Bulletin No.: PI1357

# Service Bulletin

**Subject:** Air Bag Light On, Service Air Bag Message Displayed on DIC

**Models:** 2014-2015 Buick Enclave  
2014-2015 Chevrolet Traverse  
2014-2015 GMC Acadia

3990285

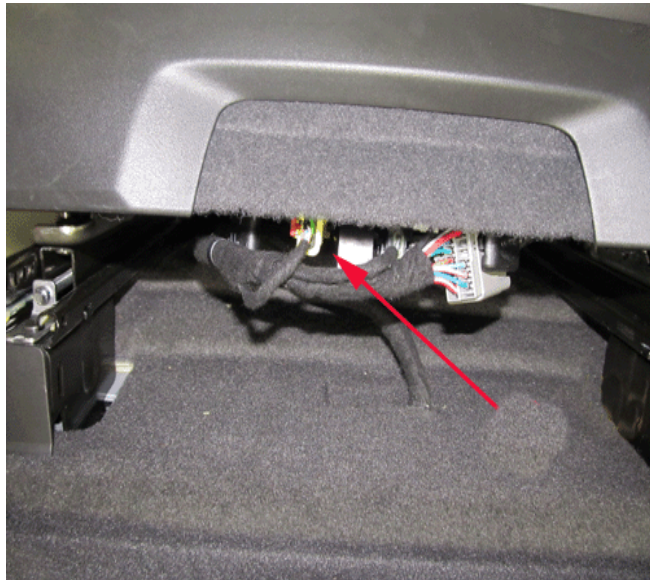
This condition may be caused by high resistance due to the crimping of the terminals in the front seat X333, X332, F106D, F106DA and F106F connectors.

To resolve this condition, the female terminals of the affected connector(s) should be soldered at the crimp using the procedure below. Perform this procedure below only to the female terminals, performing any service to the male terminals may result in damage to the terminal or connector. Only perform the repair on the appropriate seat based on the DTC(s) set.

2. Move the front seat(s) that the repair is being performed on to the most rearward and upward position to access the connector(s).

3990716

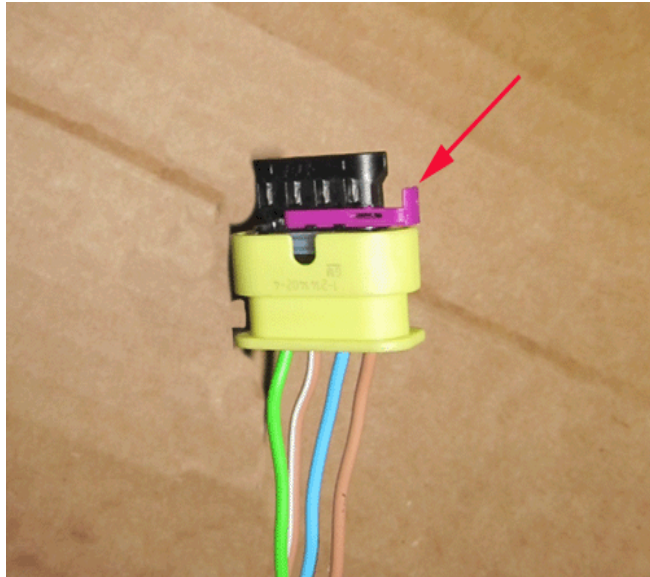
**Note:** A yellow 4-way connector (passenger) as shown above is similar to the 6-way yellow connector (driver).

3. Disconnect the connector(s) X333 or X332.
4. Remove 76 mm (3 in) of tape from the body side of the connector to gain access to the wires.

5. Remove the terminal position assurance (TPA) lock as shown above.

4009530

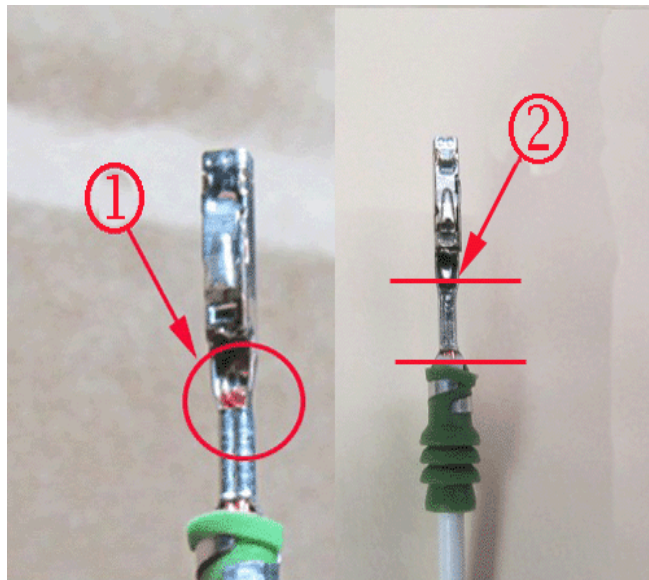
**Note:** Always use care when removing a terminal position assurance (TPA) in order to avoid damaging it.

6. Remove each terminal using the J-38125-12A and add a small amount of solder to the crimp.
  - Point the terminal upward so the solder does NOT flow into terminal.
  - Cover the exposed wires (1) with solder in the terminal.
  - Fill the crimp of terminal with solder (2).

**Caution:** Use of a small amount of solder is required or possible terminal damage or improper terminal fit into connector could result.

**Note:** Use rosin core lead solder. The higher the lead content the better as it has lower melting point.
